Aquatherm Technical Bulletin

201407A.1 - AQTTB **4" Flange Adapters** Date Issued: 9 July 2014

Figure 2: 4" Flange Adapter No. 0115526 with 4" Flange Ring No. 3315726.

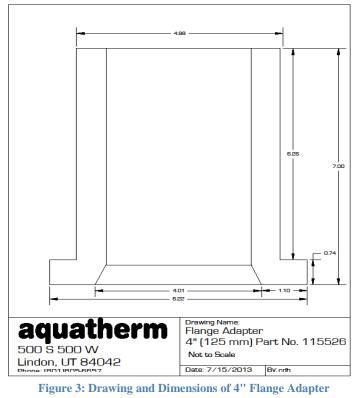
This flange adapter has an elongated neck to allow fusing a coupling socket type connector (part number 0115526) on the end of it to continue the pipe line. As can be seen in the photo the 4" flange ring (part number 3315726) fits nicely over the adapter and up to the flange adapter neck. This allows a connection to a ball valve, a butterfly valve or another flange.

Also notice that the flange ring has eight holes. This allows for the connection to another flange ring of similar configuration or to a ball or butterfly valve. If the opposite valve or ring to which you are connecting only has four holes, the eight hole ring will still work and function well. Simply use the four holes that you need. All of Aquatherm flange rings are designed to fit with ASME 150-psi flange bolt patterns.

Figure 4: Flange Adapter No. 0115527 Fused on 4" (125mm) pipe

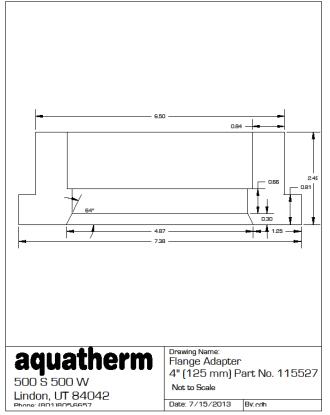
This flange adapter is a coupling, socket-type connector designed to fuse directly over a 4" pipe. It is designed to connect to an ANSI 5" pipe and flange. It was used to connect to the old-style Aquatherm ball valve that was discontinued a couple of years ago.

Since this part is no longer listed in the catalog it is suggested that this part no longer be ordered to eliminate confusion and difficulties on the job.

Figure 6: Two upper photos: 4" flange ring (No. 3315726) does not fit on 0115527. Lower photo shows 6" flange ring (No. 3315730) on 0115527 flange adapter.

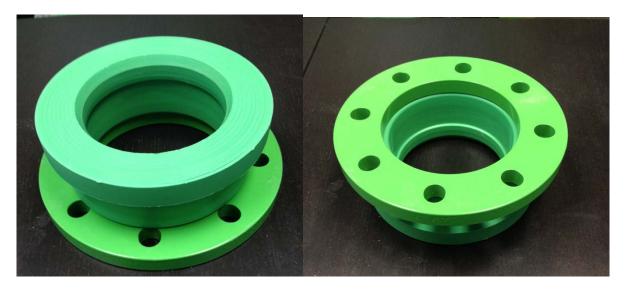
The 4" flange ring (part number 3315726) does not fit with this flange adapter as can be seen in the photos below.

The correct flange ring to use with this flange adapter is part number 3315730 which is actually a 6" flange ring. But if you are trying to connect to a 4" valve or other 4" flange adapter they will not mate up properly to the 0115527. It can only be used to make a connection to another Aquatherm pipe with the same 0115527 flange adapter.
